CITY of NOVI CITY COUNCIL

Agenda Item C
October 28, 2013

SUBJECT: Approval of the request of Robertson Charneth Fen LLC for JSP 13-51 Charneth Fen Revised Preliminary Site Plan with PD-1 Option and Special Land Use Permit. The property is located in Section 10 of the City on the south side of 12 ½ Mile Road, west of Novi Road in the RM-1, Low Density Low-Rise Multiple-Family Residential District and totals 4.66 acres. The applicant is proposing an altered footprint and slightly altered layout for the site along with revised elevations and floor plans to complete the development of the site.

PLAN REVIEW CENTER REPORT

LANDSCAPE PLAN (SOUTH END)

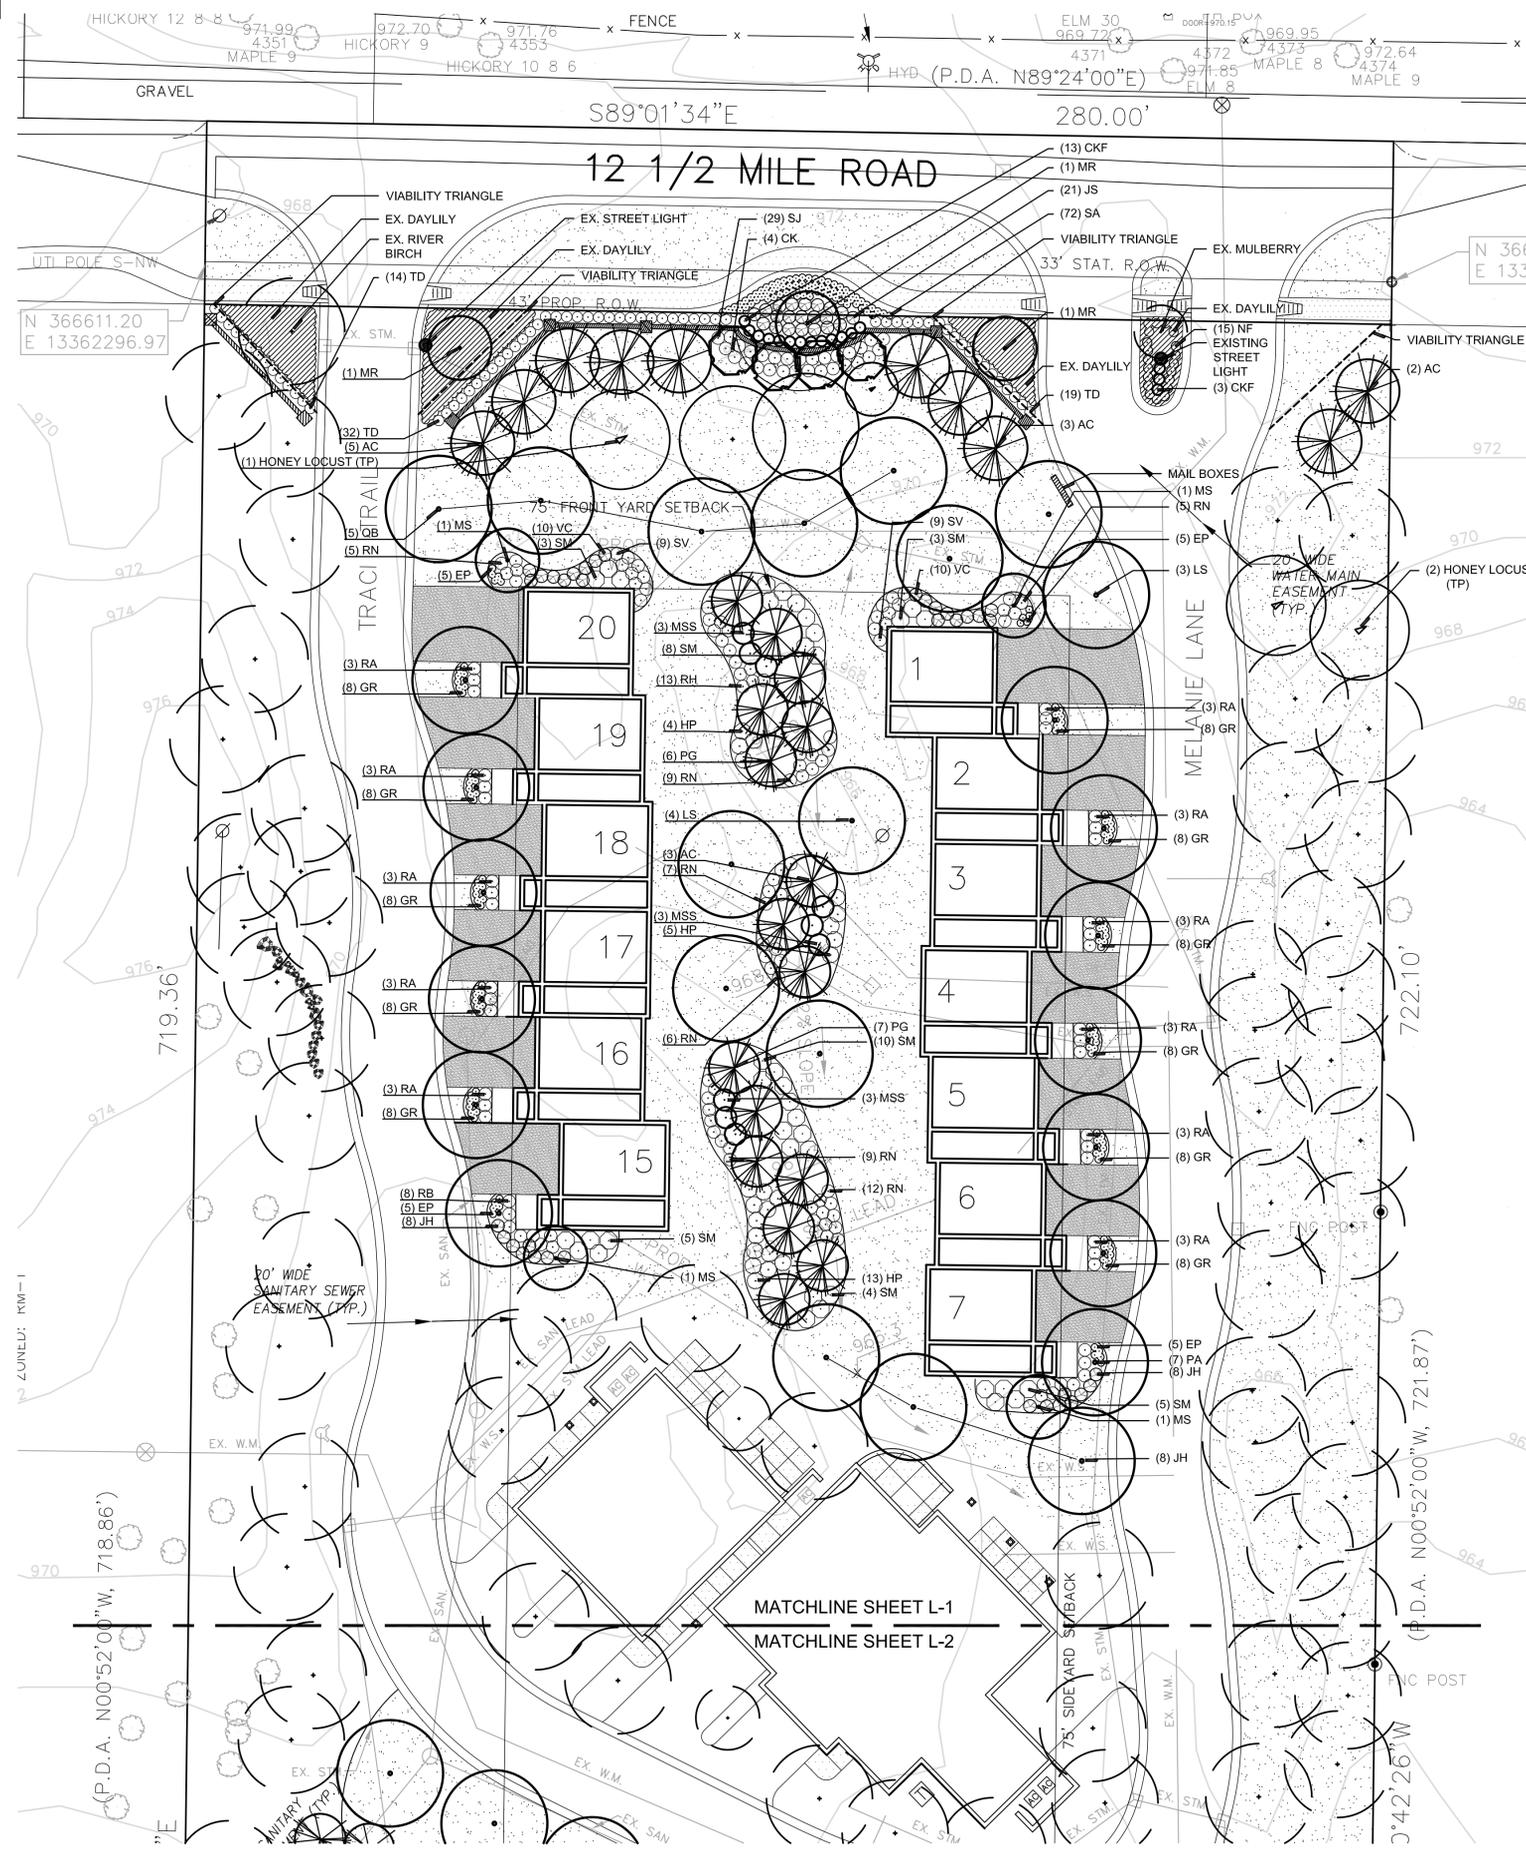
1. One street tree is required per 45 LF of frontage. No street trees have been proposed. **The applicant must provide the calculation for required street trees and provide the plantings. Alternately the applicant could seek a waiver from the City Council. Staff would not support the waiver.**

The applicant would like to request relief from the requirement for one street tree per 45 lf of frontage. The entire perimeter of the site is landscaped and the units facing the street with the drives don't provide adequate planting areas for that amount of street trees. The applicant would like to plant street trees every 45' feet where there are not existing or proposed drives. All landscape material sizes will be adjusted to meet Novi's ordinances.

STORM WATER MANAGEMENT PLAN

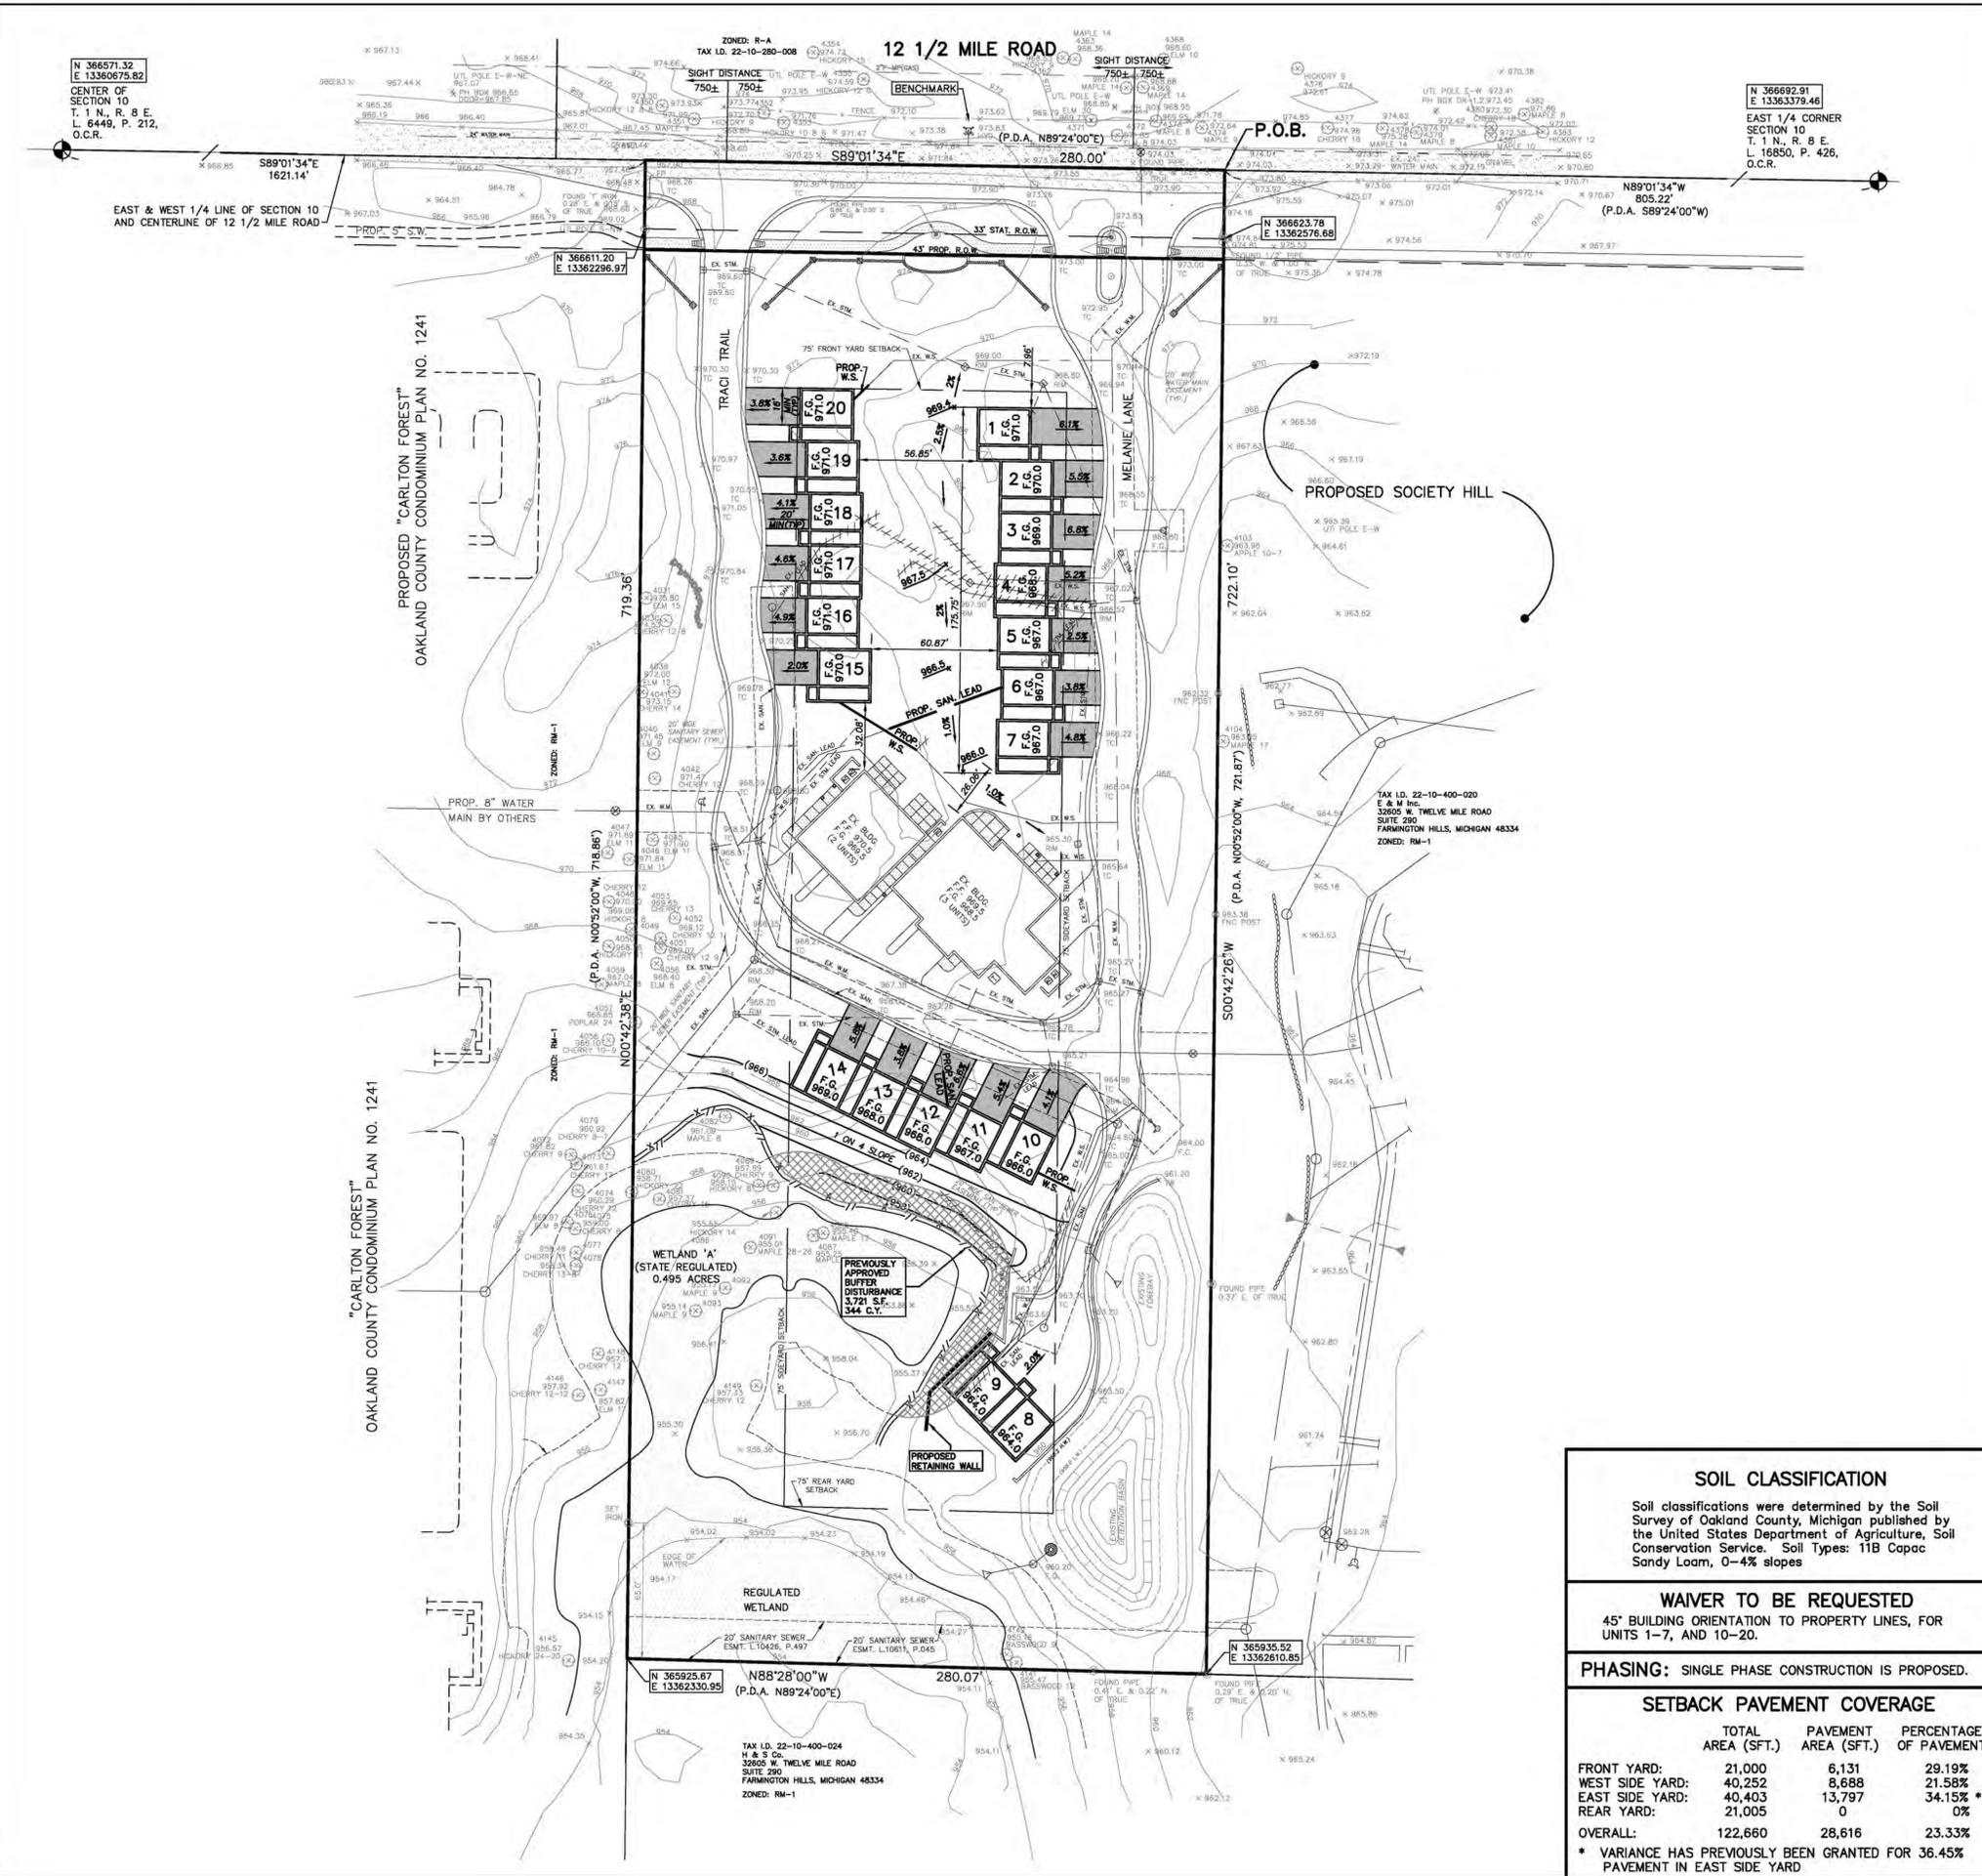
8. Verify that the existing catch basin to the south of Unit 7 is capable of accepting the runoff generated by the proposed backyard swale. The intake capacity of each catch basin may not exceed 0.011 cubic feet per second (cfs) per square inch of opening.

9. A minimum slope of 2% must be maintained in the proposed swale. There are multiple runs of the swale that do not meet this requirement.
10. Provide top-of-wall and bottom-of wall grades for the proposed boulder retaining wall. All walls four (4) feet and higher require a permit for construction from the Community Development Department prior to site construction commencing.

The applicant will address all of the engineering review comments as indicated in the Final Site Plan submittal and does not note any areas of concern addressing the comments.
